**SUBJECT: Seneca Army Depot Activity, Response to Comments on Draft Final Decision Document for the Inhibited Red-Fuming Nitric Acid (IRFNA) Disposal Sites (SEAD-13)**

**Subject:** Draft Final Decision Document for SEAD-13  
Seneca Army Depot  
Romulus, New York

**Subject:** Draft Final Decision Document – Mini Risk Assessment for the Inhibited  
Red Fuming Nitric Acid (IRFNA) Disposal Site (SEAD-13)  
Seneca Army Depot  
Romulus, New York

FIGURE 2-10

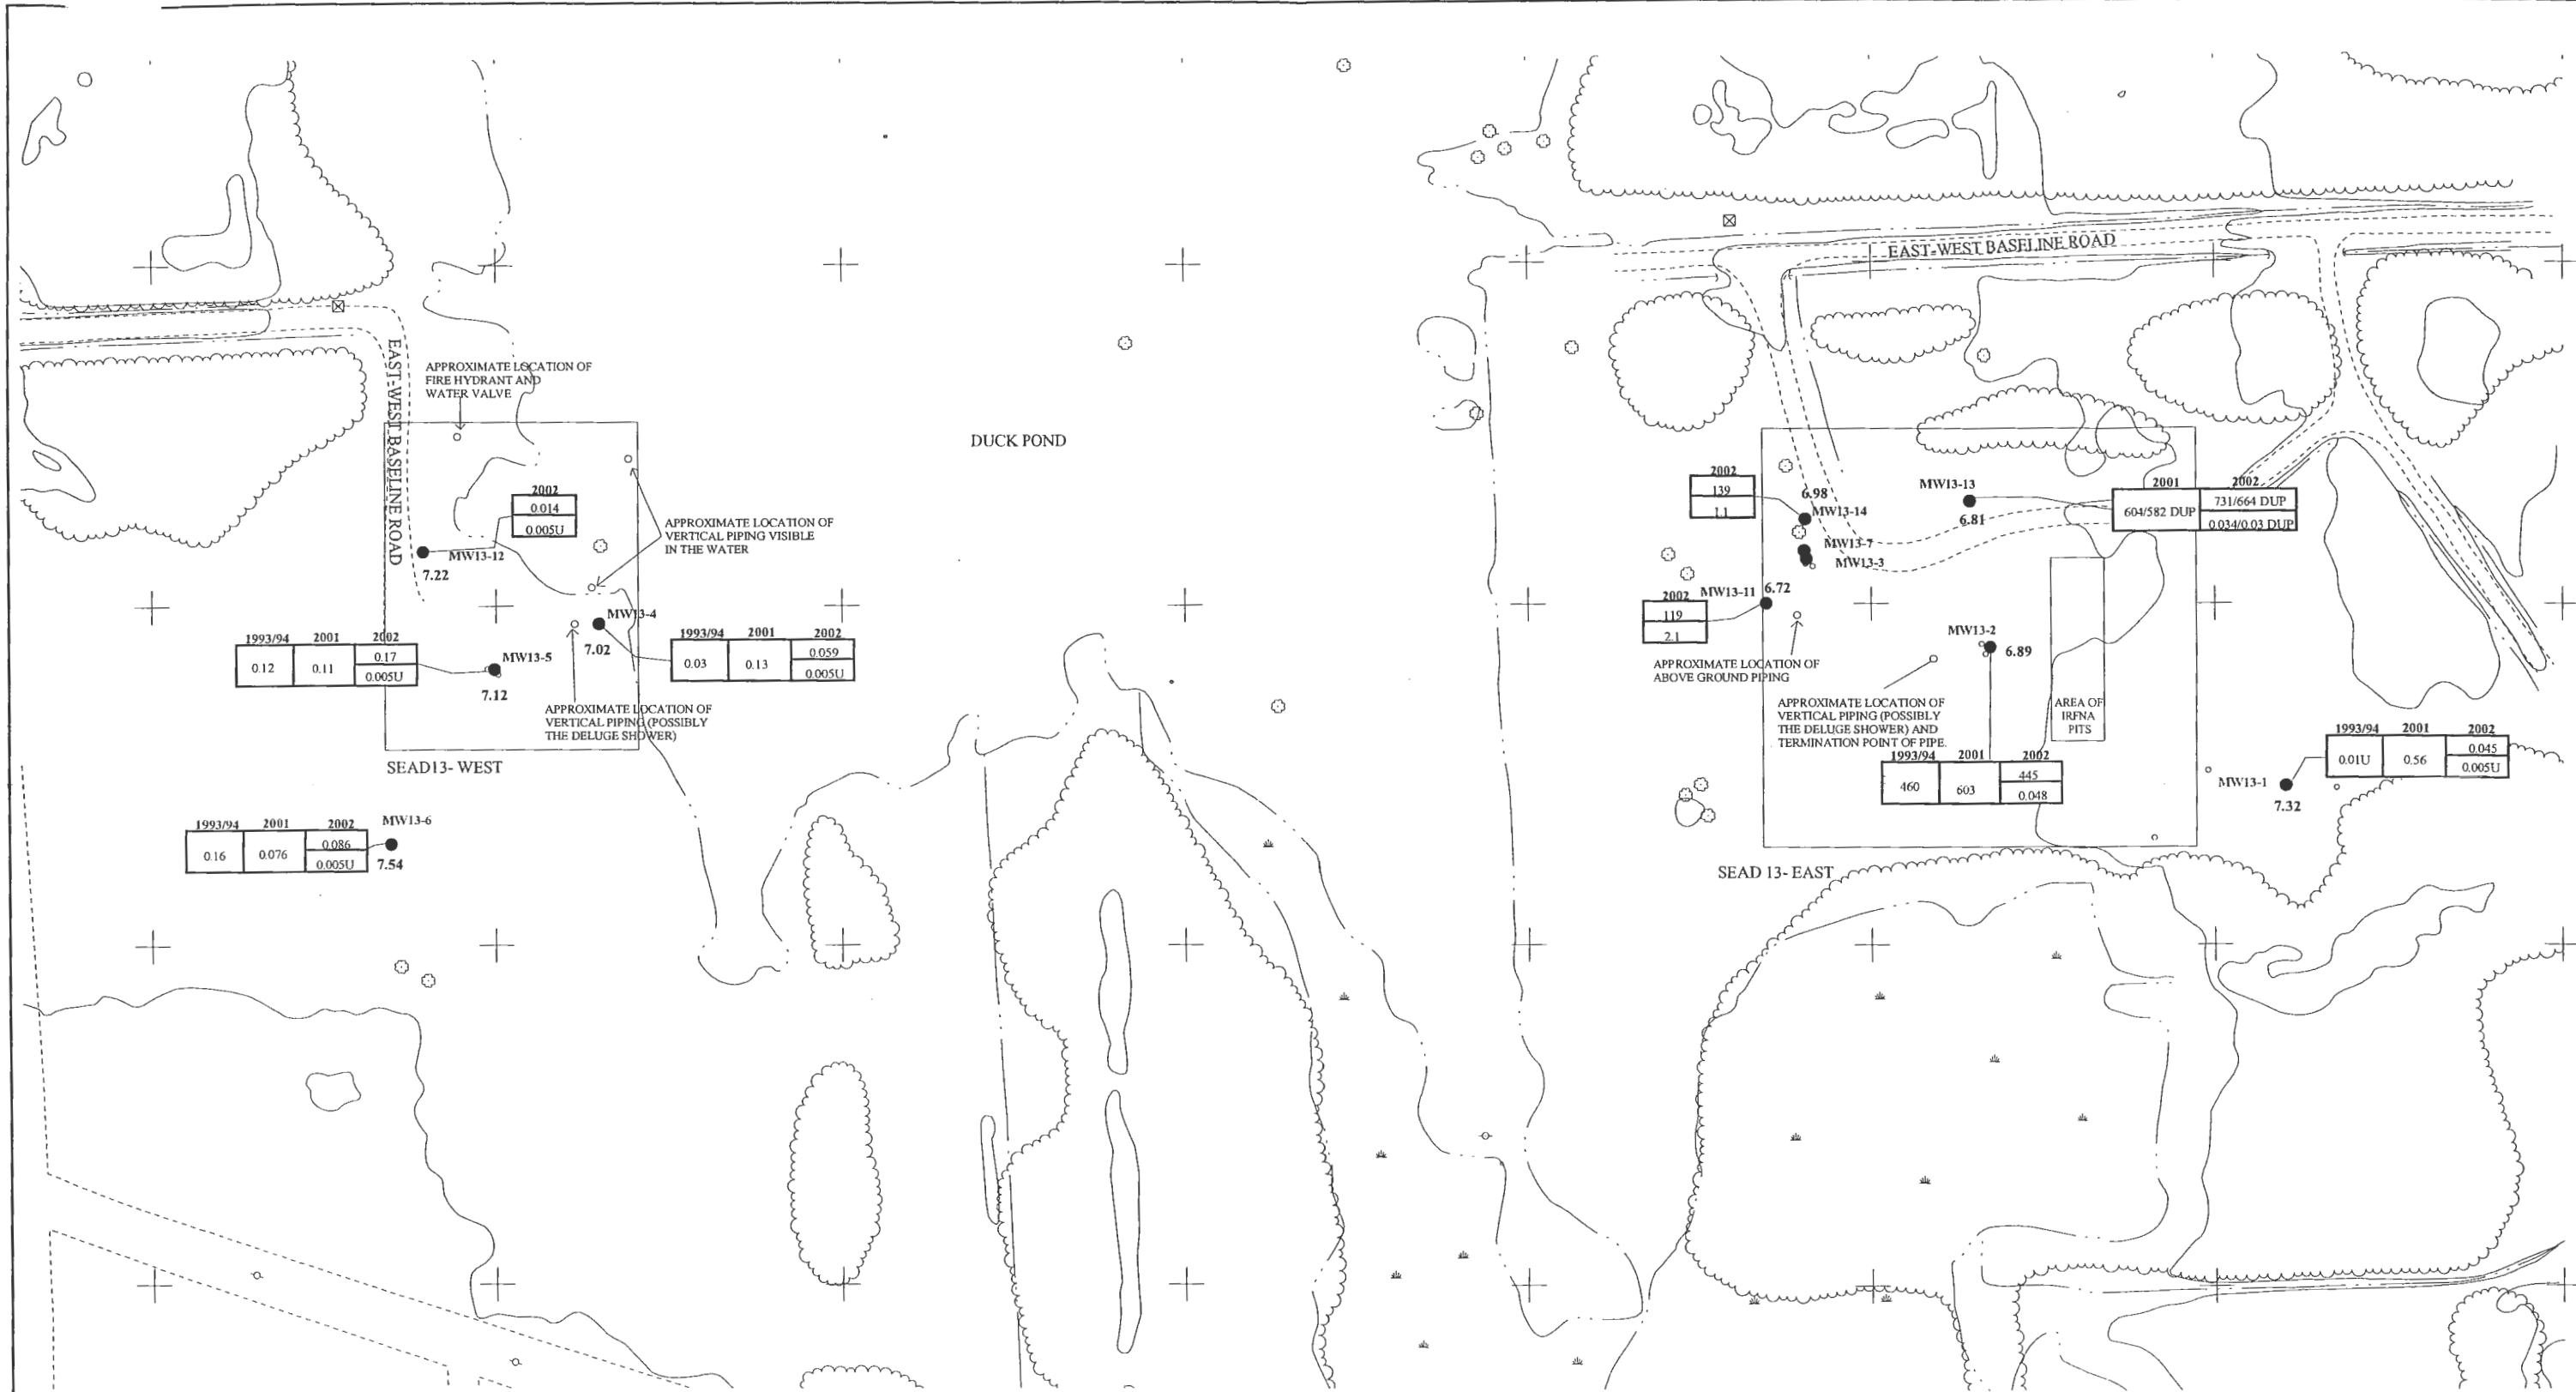
**Comment 5:** Clarification is sought as to why soil boring samples were not collected within the disposal pits. It is unclear how much soil, if any, is actually in the pits or if the disposal pits are even considered soil. The analysis of the waste for contaminants of concern (i.e., degradation products of IRFNA) and the physical parameter of pH would allow for a more complete evaluation of the potential for future exposures and additional migration of contaminants to surrounding soil and groundwater. In addition, the pH of the soil and groundwater adjacent to the pit area was not examined. As stated above, this information is necessary to evaluate the potential of (disposal pit related) decreased pH of soil or groundwater to leach "site background" inorganics not related to the disposal of IRFNA from surrounding soils into groundwater and subsequently the Duck Pond. In the document discussion of groundwater contamination, the Army states that some of the elevated inorganics, decreased pH and background leaching may also be the cause. Without turbidity data or dissolved inorganic/pH data, these two scenarios cannot be separated as to which may be the cause of the elevated inorganics.

As shown on Figure 2-10, a review of groundwater sampling parameters shows that the pH of the groundwater at SEAD-13 is not lowered and is in the same range as the pH of groundwater at other background locations at SEDA. The pH levels measured at the site does not cause additional leaching of metals.
